UNLESS OTHERWISE SPECIFIED TOLERANCE		SCALE: AS SHOWN		UNIT: mm	
ANG.	±3°	DRAWN	RILEY	04/18/2019	DRAWN NAME:
.0	±0.30	CHECKED		/ /	HD MINI SAS 36P/HD MINI SAS 36P
.00	±0.20	APPROVED		/ /	Cable △X6 1/2
		SIZE	A4	REV.	X8
		FILE NAME:		C10C213B05E01(25)(緯創)

CHANT SINCERE CO.,LTD

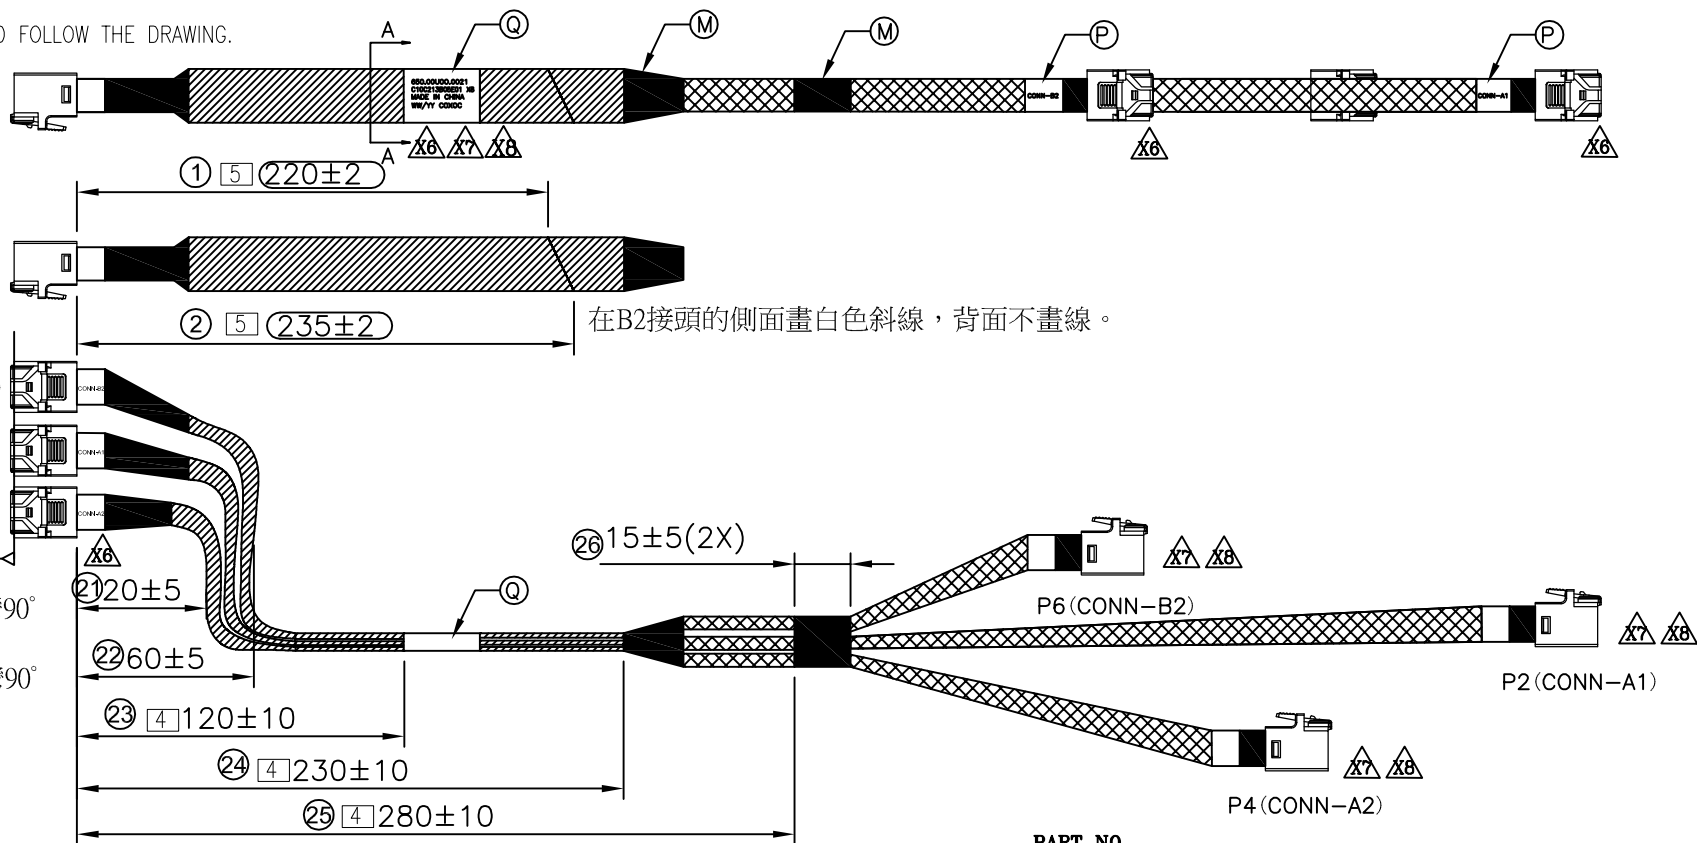
X8 ECR-(Riley) CANCEL H.S.T,Modify Wistron PN & 折彎尺寸 △X8

X7 ECR-(Riley) CANCEL FOAM ADD Protective case & 新增H.S.T & 折彎尺寸 △X7

X6 ECR-191009(Teresa) Modify NEW TYPE 4X & DESCRIPTION & CANCEL H.S.T △X6

△X8 5 距連接器20mm處預折彎90°

△X8 5 距連接器60mm處預折彎90°
